**COVER LETTER FOR  
THE UP DATING OF THE ORIGINAL REPORT: MARCH 27, 2024  
WITH OPTIONS: FOR FULL BAY REPLACEMENTS OR  
PARTIAL BAY REPLACEMENTS  
AUGUST 7, 2025**

**AIR CITY GARAGE  
27 S. JEFFERSON STREET  
DAYTON, OH 45402**

**Add August 6, 2025 for Pricing**

Project No.24.200.020

## TYPICAL PARKING GARAGE LEVEL PLAN

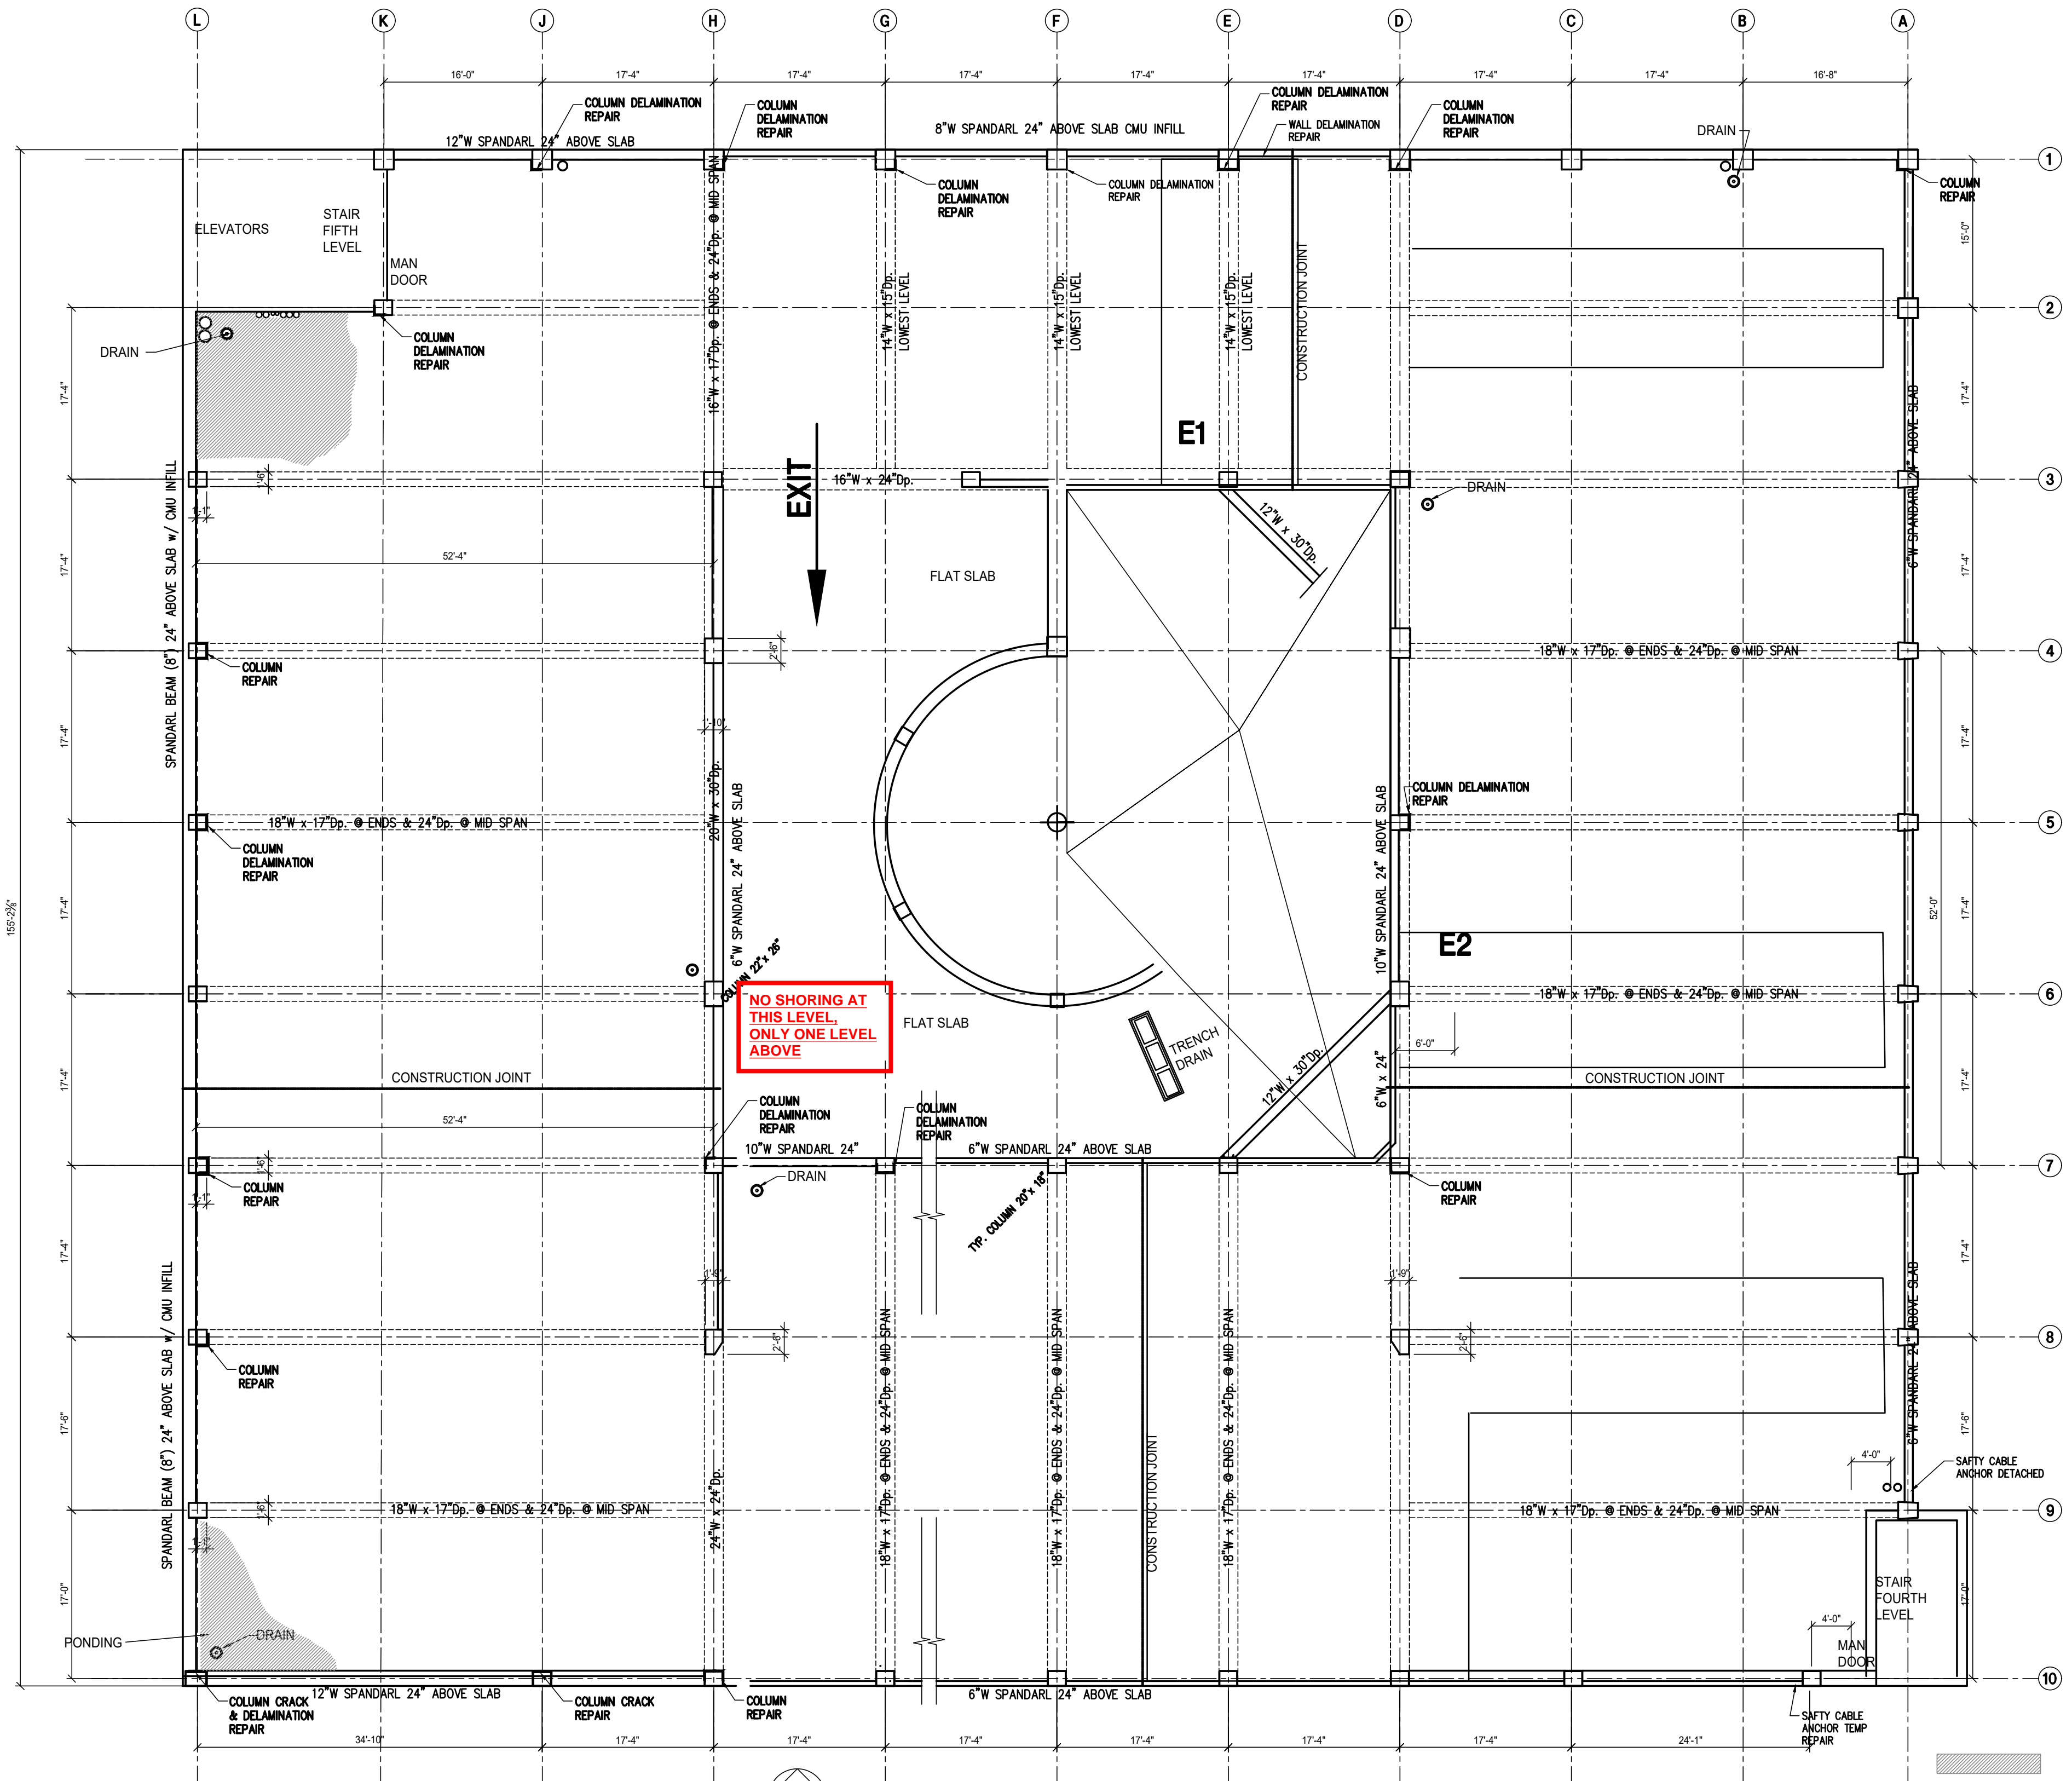
Demo 11 FULL Bays at \$28,000 Each = \$308,000  
Demo 2 One-Half Bays at \$16,000 Each = \$32,000  
Place Beams in 13 Bays at \$10,000 Each = \$130,000

Remove	Floor Delams	Ribs Lin Ft	Soffit
First Add 790 6"Slab	107 Sq Ft.	99	189 Sq Ft.	
Second Add 790 6"Slab	300 Sq Ft.	24	297 Sq Ft.	
Third Add 790 6"Slab	180 Sq Ft.	80	274 Sq Ft.	
Fourth Add 790 6"Slab	12 Sq FT.	77	327 Sq FT.

Remove Floor Delams	Ribs Lin Ft	Soffit
Second Add 440 6"Slab	12 Sq Ft.	15 193 Sq Ft.
PLUS ENTIRE CONSTRUCTION JOINT

Remove	Floor Delams	Ribs Lin Ft	Soffit	Fourth Add 540 6"Slab
150 Sq Ft.	50	274 Sq Ft.

Remove	Floor Delams	Ribs Lin Ft	Soffit
Second Add 790 6"Slab		200 Sq Ft.	34	230 Sq Ft.
Third Add 790 6"Slab		60 Sq Ft.	43	79 Sq Ft.
Fourth Add 790 6"Slab		20 Sq FT.	25	59 Sq FT.

Remove	Floor Delams	Ribs Lin Ft	Soffit
Third Add 790 6"Slab	60 Sq Ft.	43	79 Sq Ft.
Fourth Add 790 6"Slab	20 Sq FT.	29	59 Sq Ft.

Remove	Floor Delams	Ribs Lin Ft	Soffit
Third Add	790 6"Slab	200 Sq Ft.	60	84 Sq Ft.
Fourth Add	790 6"Slab	130 Sq FT.	44	330 Sq FT.

Remove	Floor Delams	Ribs Lin Ft	Soffit
Third Add 790 6"Slab	40 Sq Ft.	60	223 Sq Ft.
